DESIGN AND SUSTAINABILITY ADVISORY PANEL MEETING REPORT

DA2025/0447 - 32 Golf Avenue MONA VALE

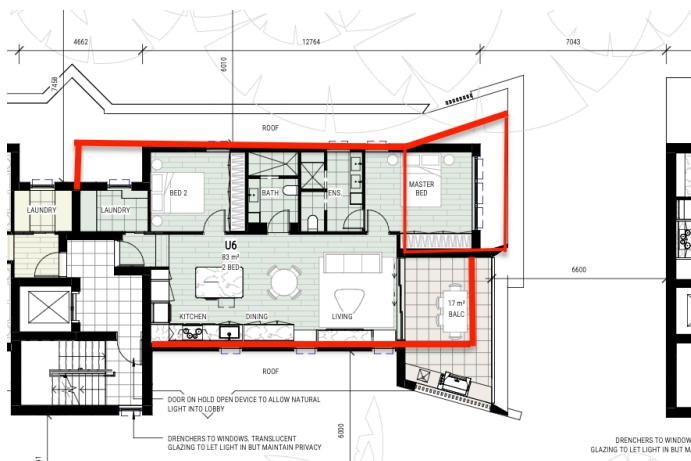
The low to mid rise housing uplift has led to the development doubling in height, from 2 storeys to 4 storeys. The proposed design sets back the top 2 floors from the lower floors along the north-western elevation of both proposed buildings and for most of the south-eastern elevation of both buildings. This is a considered response to designing a 4-storey building in an area of 2 storey existing buildings. However, the top storeys along the south-eastern elevation are not as consistently set back as those along the north-western elevation – 2 fire stairs and a balcony stack are not set back above the second floor. The issue of proximity to neighbours is more acute along the south-eastern boundary as the adjoining dwellings are at their closest towards the centre of the site where they are approximately 4m from the side boundary.

It is recognised that the fire stairs are well located along the less sunny side of the building, allowing the north-western side to maximise sun access. The fire stairs are also functionally located. The balconies to Units 6 and 8 are visually overbearing on the neighbouring property. It is acknowledged that detail solar access studies have been prepared to provide at least 2 hours sun to the neighbouring windows during mid-winter, however the balcony stack contributes to overshadowing. Relocating the balconies would increase solar access to the neighbour and reduce the effect of overbearing.

It is recommended to re-work the layouts of Units 6 and 8 by “flipping” the bedrooms to the south-eastern side of the plan and the living areas and balcony to the north-western side of the plan in a layout similar to this :

- d. Re-work the layouts of Units 6 and 8 as described above to reduce impacts on neighbouring property to the south-east and enhance solar access to the proposed apartments (as described above).
